**ADDENDUM No. 2**  
**Request for Competitive Sealed Proposals (CSP)**  
**19CSP104 Renovations at Dobie Middle School**

**Addendum No. 2**

**TO:** Prospective Bidders  
**FROM:** Haddon+Cowan Architects  
**SUBJECT:** AISD Dobie Middle School Renovations

**DATE:** February 15, 2019  
**HCA PROJ. NO:** 18-1032  
**AISD PROJ. NO:** 190035-DOBIE

**2 - ELECTRICAL KEYED NOTES - NEW WORK:**

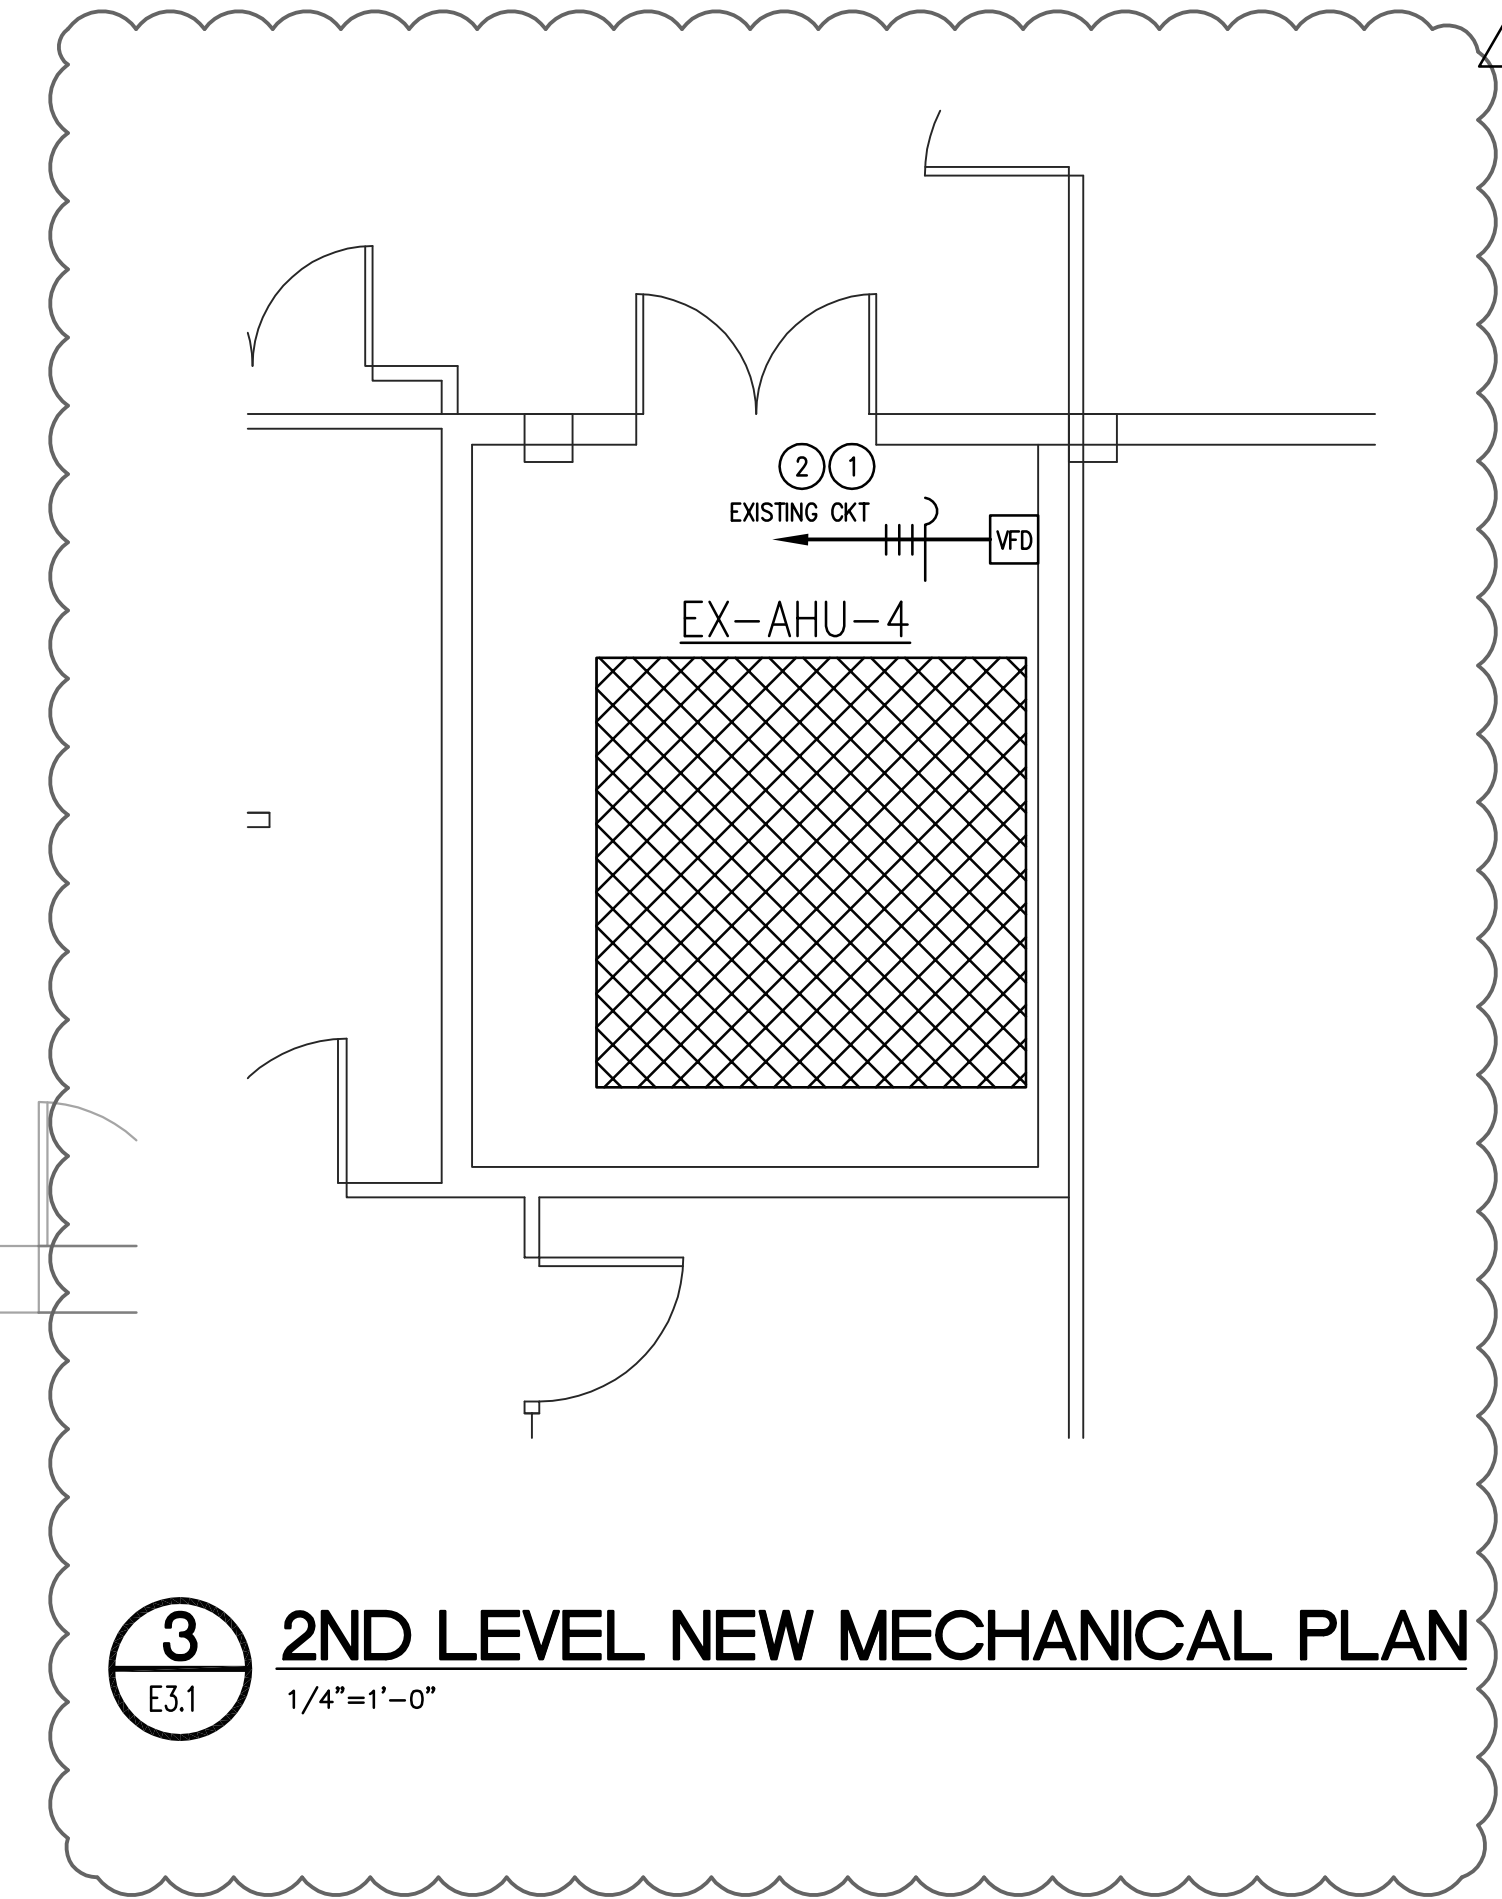
13. Sheet M5.1 – Revised and Reissued
- a. CHWP-1,2 have been revised to show lower HP rating.
14. Sheet E3.1 – Revised and Reissued
- a. Relocated CWP-1 & CHWP-2 to match mechanical plans.

- b. Updated emolition keyed note 4.
  - c. Detail 2: Updated keyed notes 1 & 2 for use of new VFD, not existing.
  - d. Added Detail 3 and keyed notes for replacement of AHU-4 VFD.

- ① CONTRACTOR SHALL COORDINATE WITH SERVICE CENTER FOR LOCATING EXISTING VFD PURCHASED DURING PREVIOUS CONSTRUCTION PHASE AND REPLACE VFD FOR EXISTING AHU-4 SERVING LIBRARY. VFD SHALL BE INSTALLED PER MANUFACTURER'S INSTALLATION INSTRUCTIONS AND BE UTILIZED FOR SOFT START ONLY DURING STANDARD OPERATION.
- ② ELECTRICAL CONTRACTOR TO REUSE EXISTING WIRE, CONDUIT & CIRCUIT BREAKER SERVING EXISTING AHU-4. VFD SPECIFICATIONS SHALL HAVE THE CAPACITY TO SERVE AHU-4. COORDINATE WITH SERVICE CENTER, AHU MANUFACTURER, VFD MANUFACTURER & ENGINEER OF RECORD PRIOR TO INSTALLATION UPON VFD & CIRCUIT CAPACITY NOT MEETING AHU REQUIREMENTS, AISD IS PAY FOR MEP DESIGN AND CONTRACTOR INSTALLATION OF SERVICE CENTER VFD.

**1 KITCHEN DEMO PLAN**  
E3.2 1/16"=1'-0"

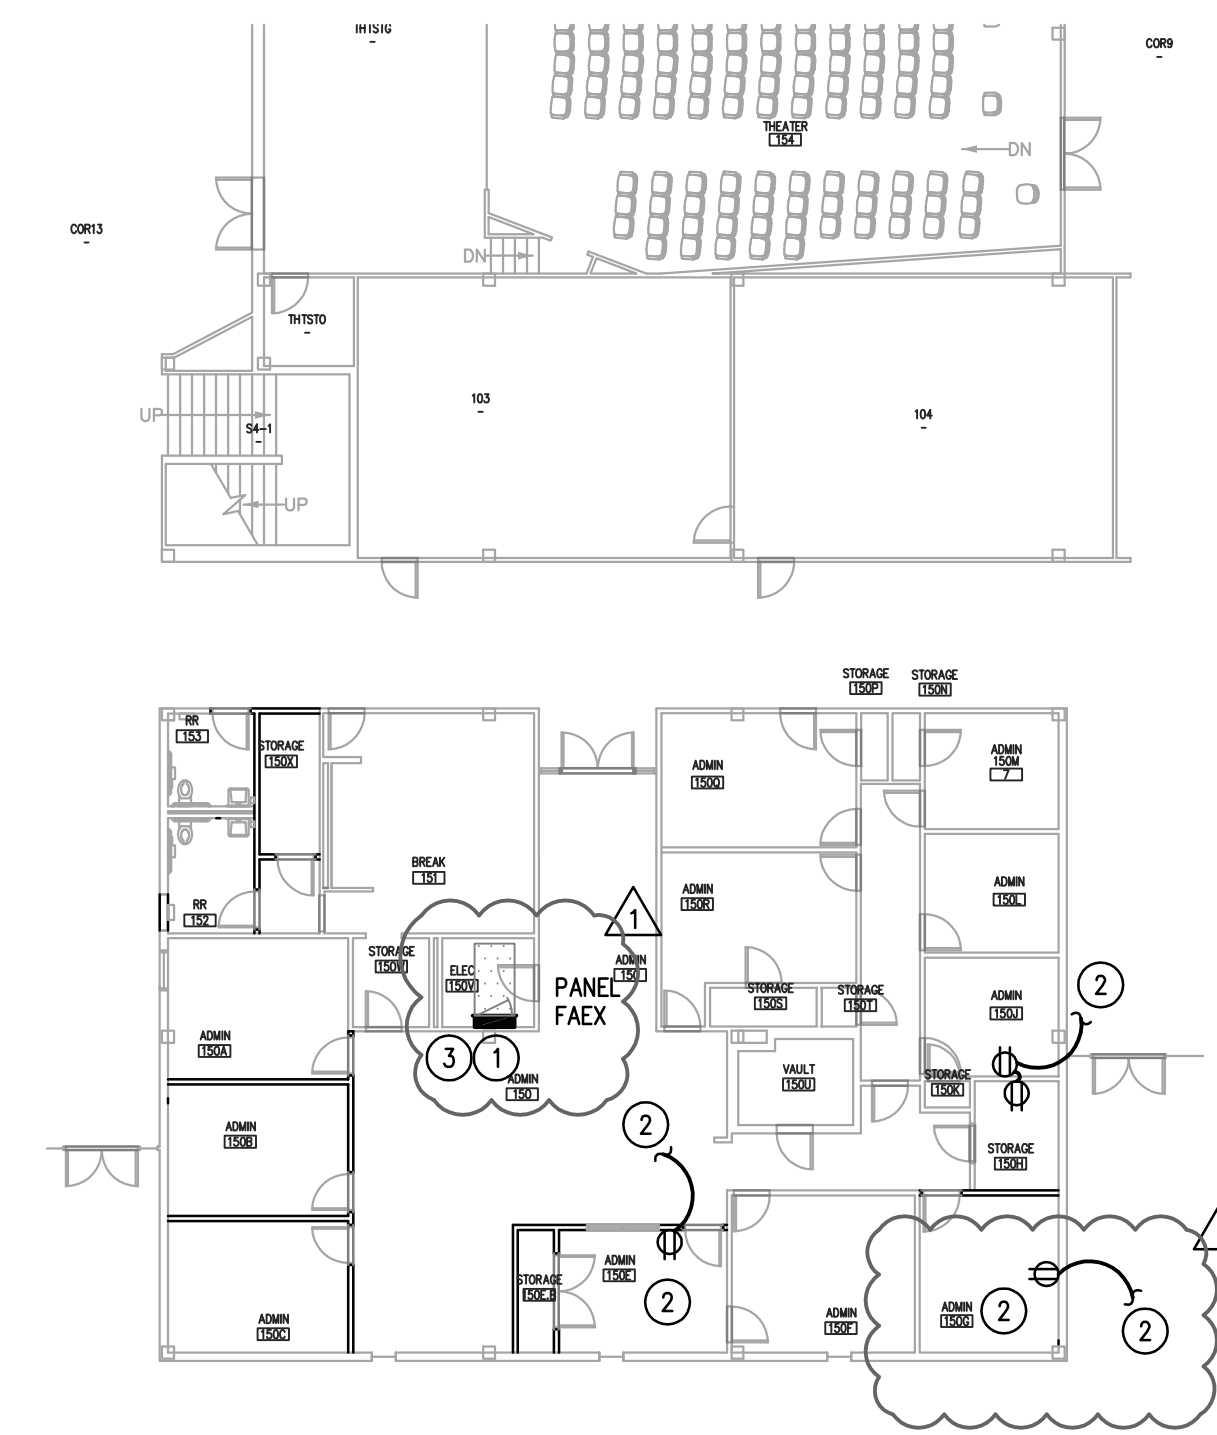
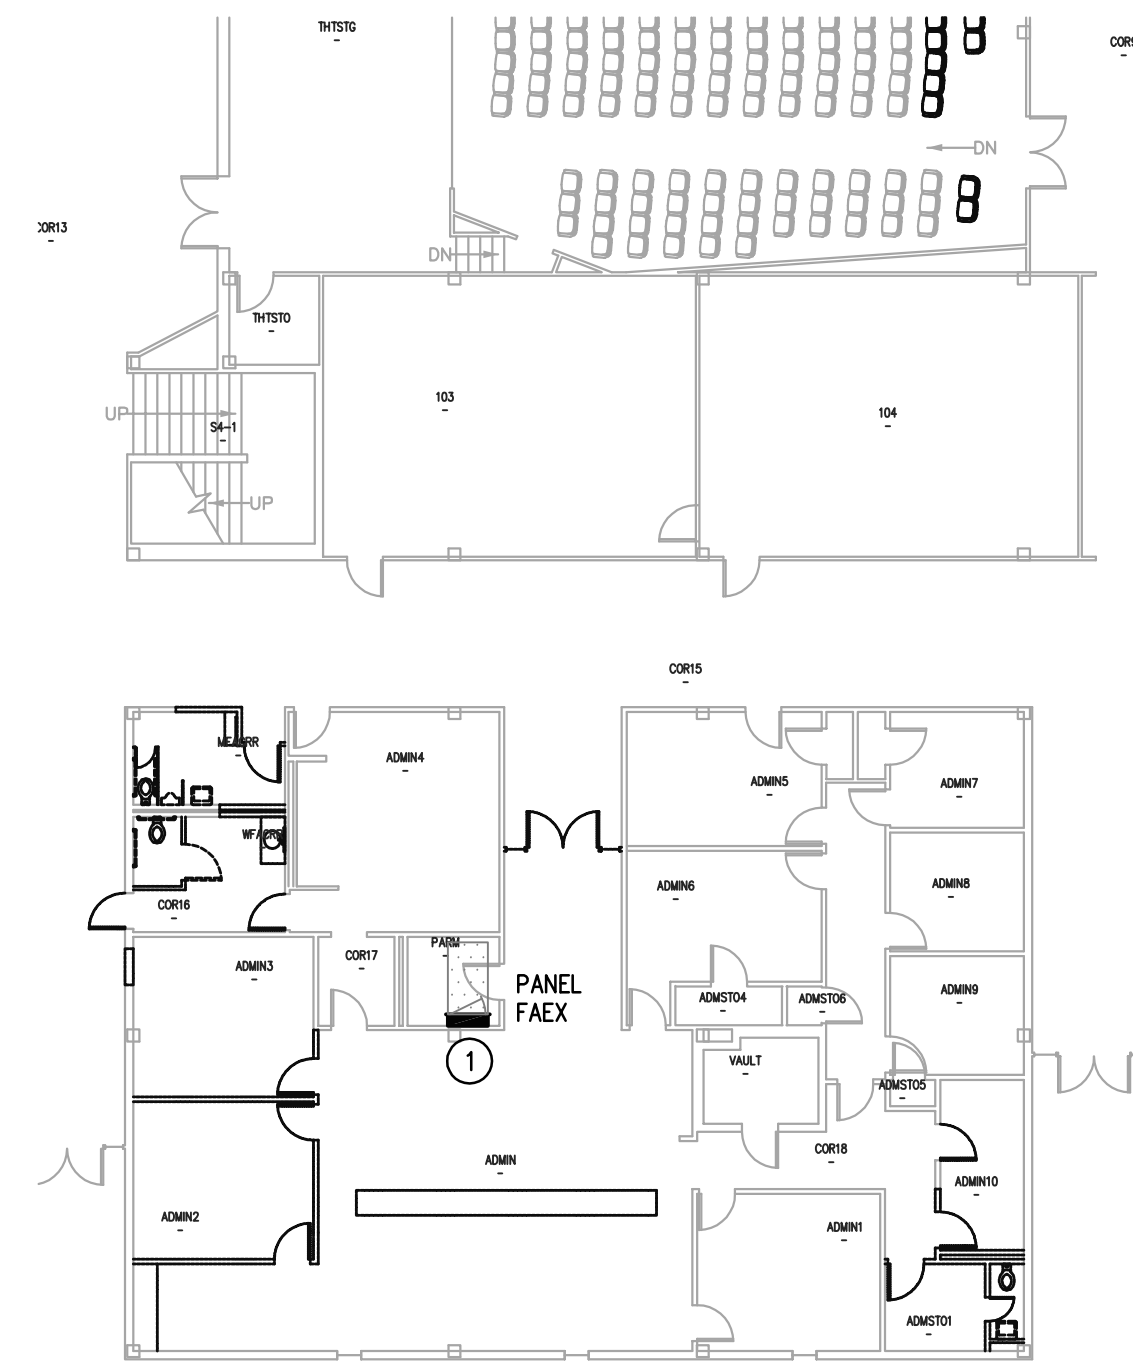
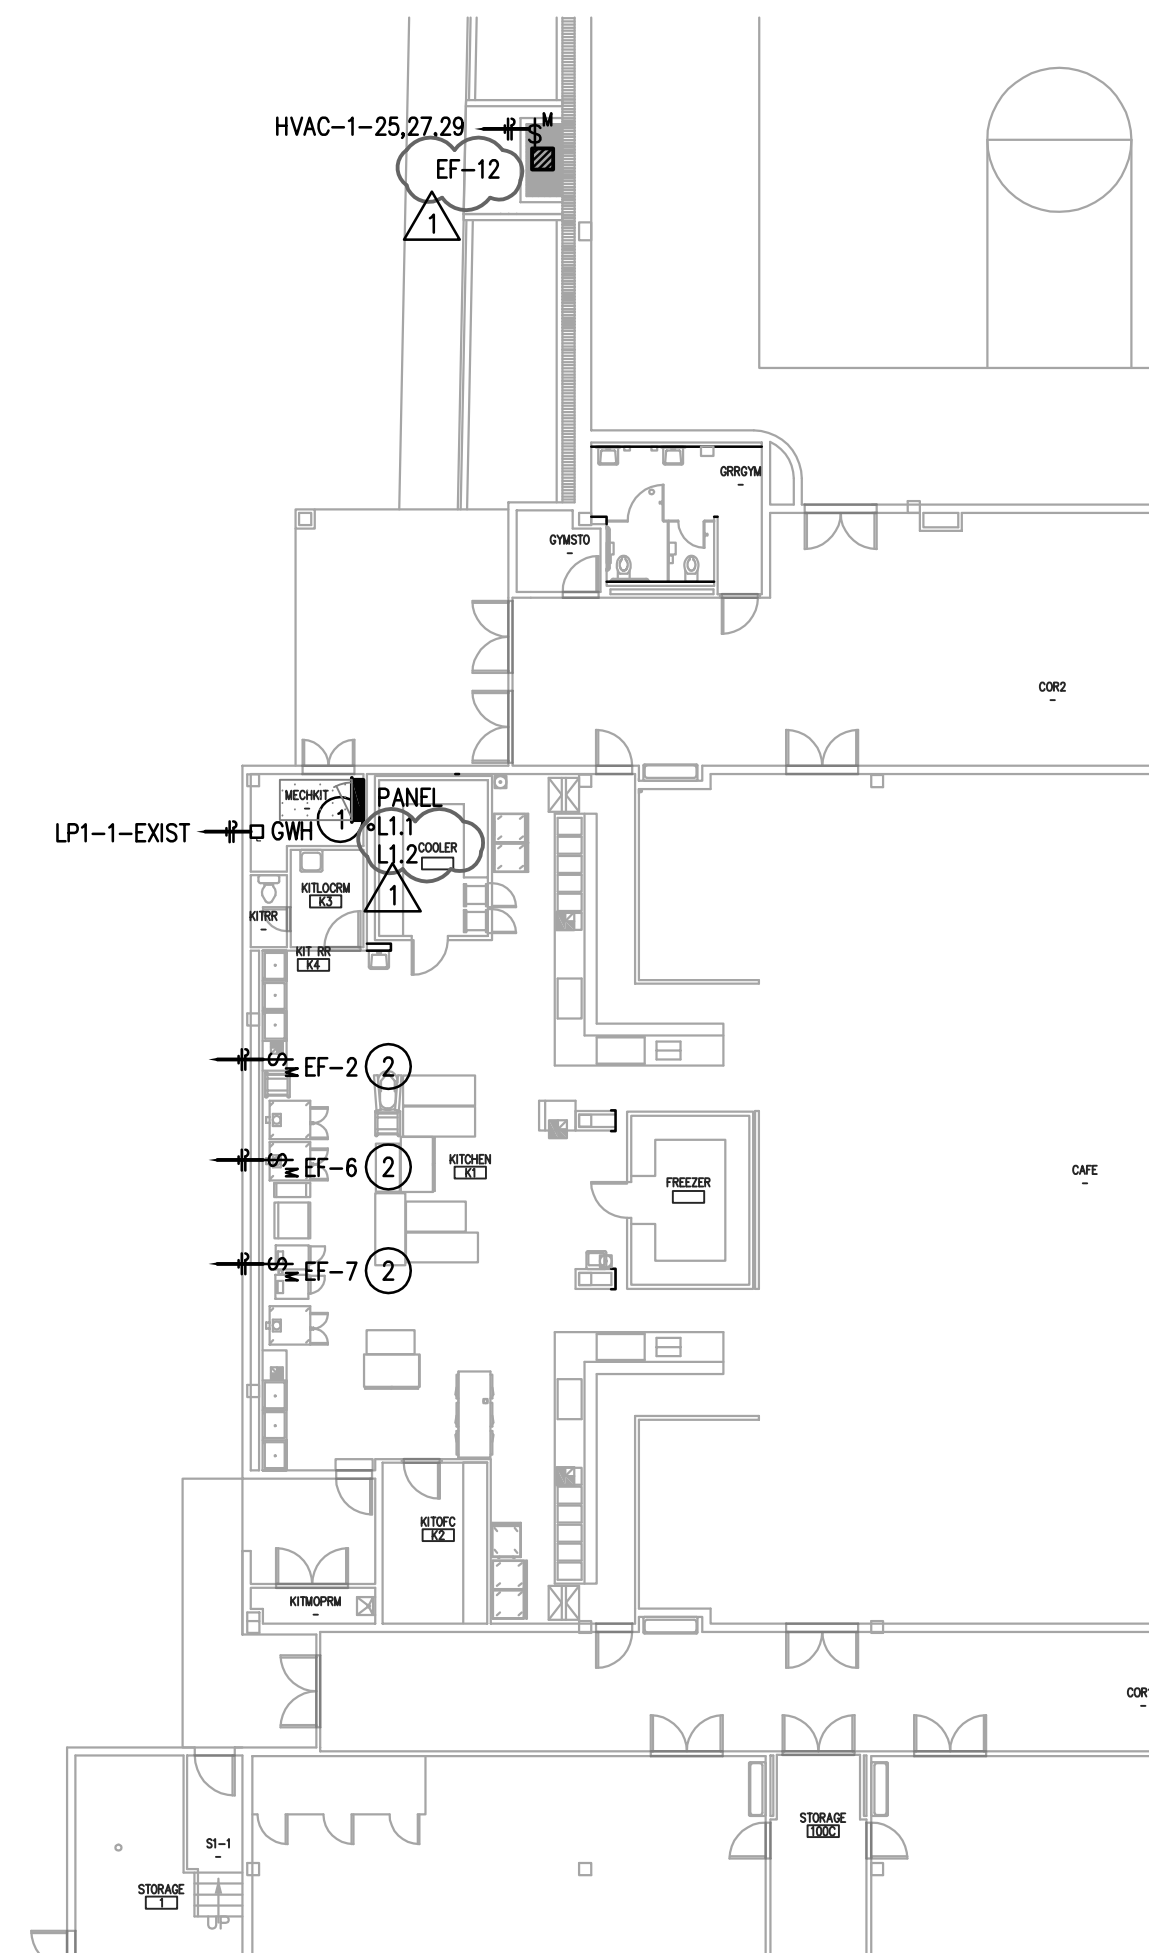
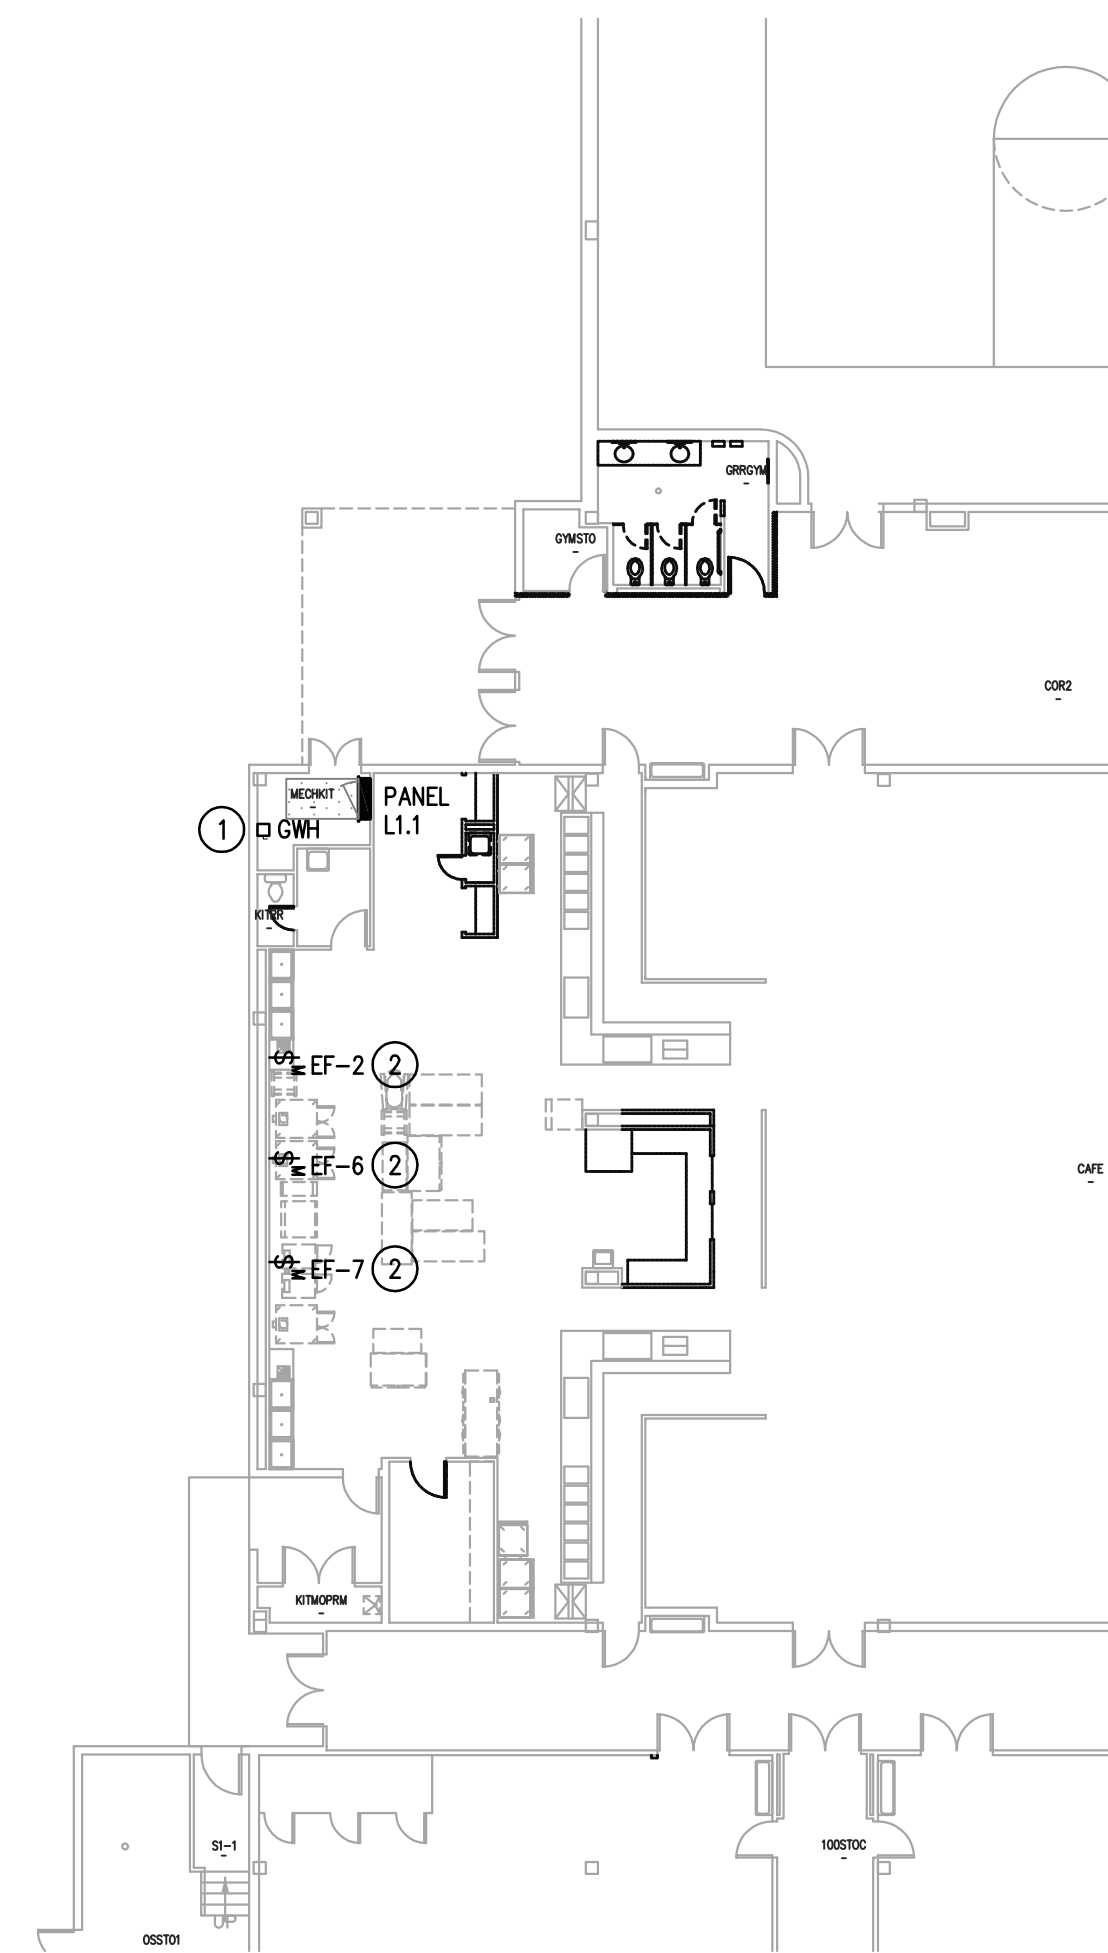
15. Sheet E3.2 – Revised and Reissued
- a. Detail 1: Updated keyed note 1 from GWP-1 to GWH-1.
  - b. Detail 2: Added L1.2 annotation to match riser diagram.

- c. Detail 2: Updated keyed note 1.
  - d. Detail 2: Updated EF-2DM to EF-12 to match mechanical plans.
  - e. Detail 4: Relocated receptacle from Admin 150F to Admin 150G.

- f. Detail 1-4: Updated scale of each view from 1/16" to 1/4".
  - g. Detail 4: Added keyed note to replace flexible conduit with emt.
16. Sheet P1.2 – Revised and Reissued

- 1 EXISTING GAS WATER HEATER TO BE REPLACED. GAS WATER HEATER "GWH-1" POWER CONNECTION TO REMAIN FOR FUTURE USE.
- 2 EXISTING EXHAUST FAN TO BE REPLACED. EXHAUST FAN "EF-2, EF-6, EF-7" POWER CONNECTION TO REMAIN FOR FUTURE USE. VERIFY BREAKER AND WIRE SIZE.
